SAN ANTONIO WATER SYSTEM  
DSP Southeast Tank and Pump Station Project  
SAWS Job Nos. 13-6102 (DSP) & 13-6005  
Solicitation No. B-14-062-MF

ADDENDUM NO. 1

October 6, 2014

A-5a

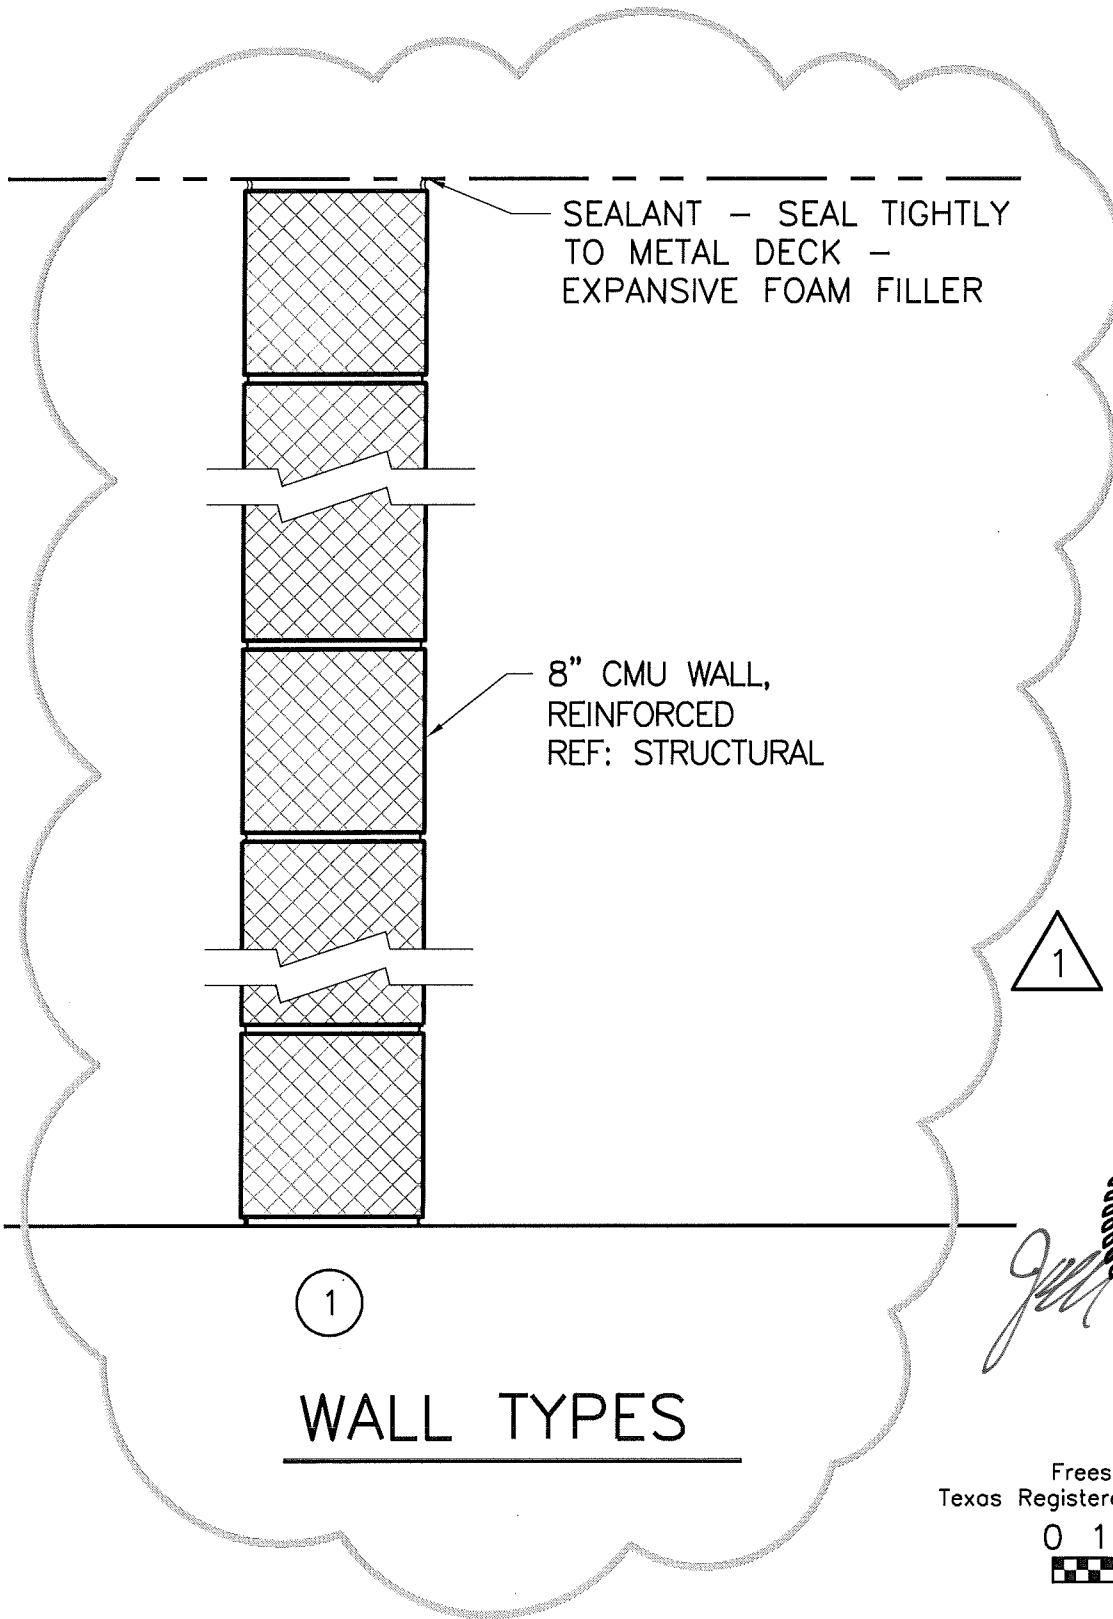
1. SHEET A-5:

- a. REPLACE Wall Types call out “Fire Sealant” with “Sealant – seal tightly to metal deck – expansive foam filler”. See Figure A-5a, attached.
- b. DELETE Note 1 “2HR Fire Wall”. See Figure A-5a.
